APPLICATION NO.	FILING DATE	FIRST NAMED INVENTOR	ATTORNEY DOCKET NO.	CONFIRMATION NO.
09/802,982	03/12/2001	Stefan Karl	1200.473	6932

Office Action Summary	Application No.	Applicant(s)	
	09/802,982	Karl	
	Examiner	Art Unit	
	Ford	3743

Claims 1, 2, 10, 11, 13 and 14 are rejected under 35 U.S.C. 103(a) as being unpatentable over JA 10-76837 in view of Enomoto Figure 8, and the description thereof.

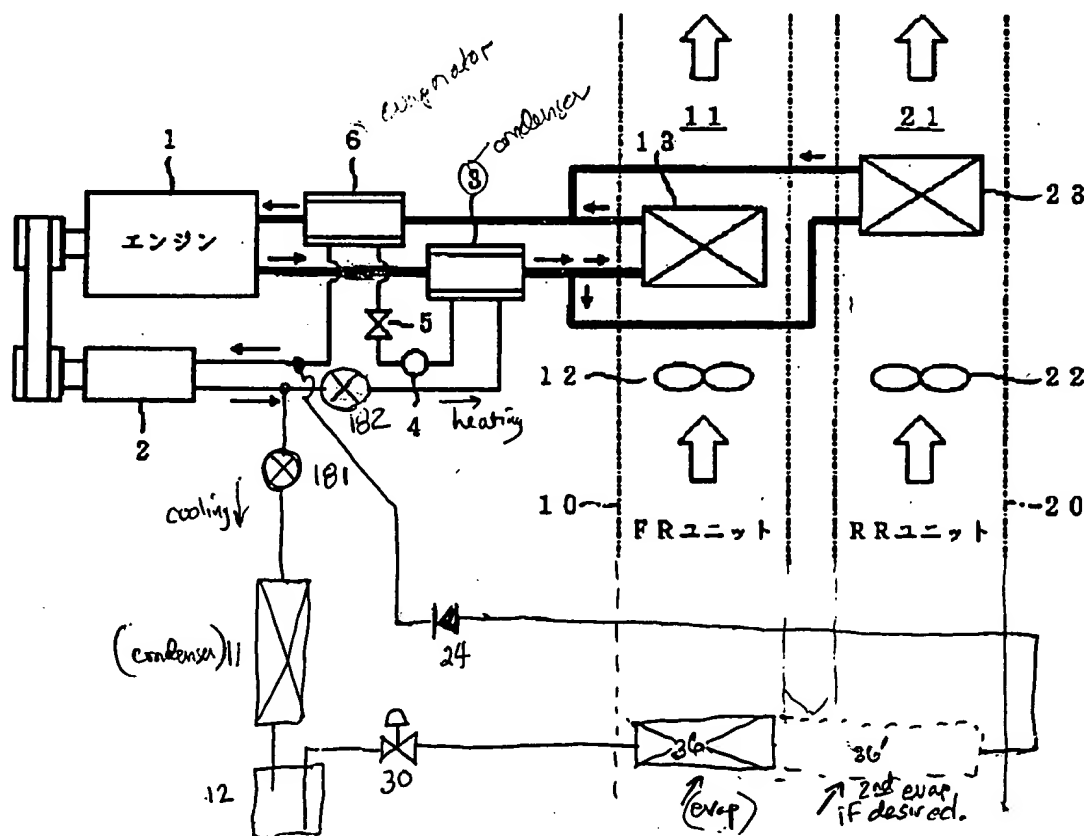
JA '837 shows a refrigerant system for beneficially increasing the heating effect of a liquid based heating system. It has no ability to cool the compartment in hot weather. The compressor 2 is known to be the most costly component of automotive refrigerant systems.

Enomoto teaches in Figure 8 a refrigerant based heater circuit (182, 13, 37, 15~~6~~) and a refrigerant based cooler circuit (181, 11, 12, 30, 36 and 24) connected in parallel across the output and inputs of the compressor 10.

To have added a refrigerant based cooler circuit (as described above) to JA '837 to give the capability of cooling in the summer as well as heating in the winter would have been obvious to one of ordinary skill in climates ^{where} ~~were~~ air conditioning was needed to preserve occupant comfort. Appropriate valves (181, 182) on the discharge side of the compressor would be necessary to separately activate the heating and cooling systems. The modification is shown below.

Regarding claim 10, see element 24 in the sketch. Regarding claim 11, see elements 5 and 30.
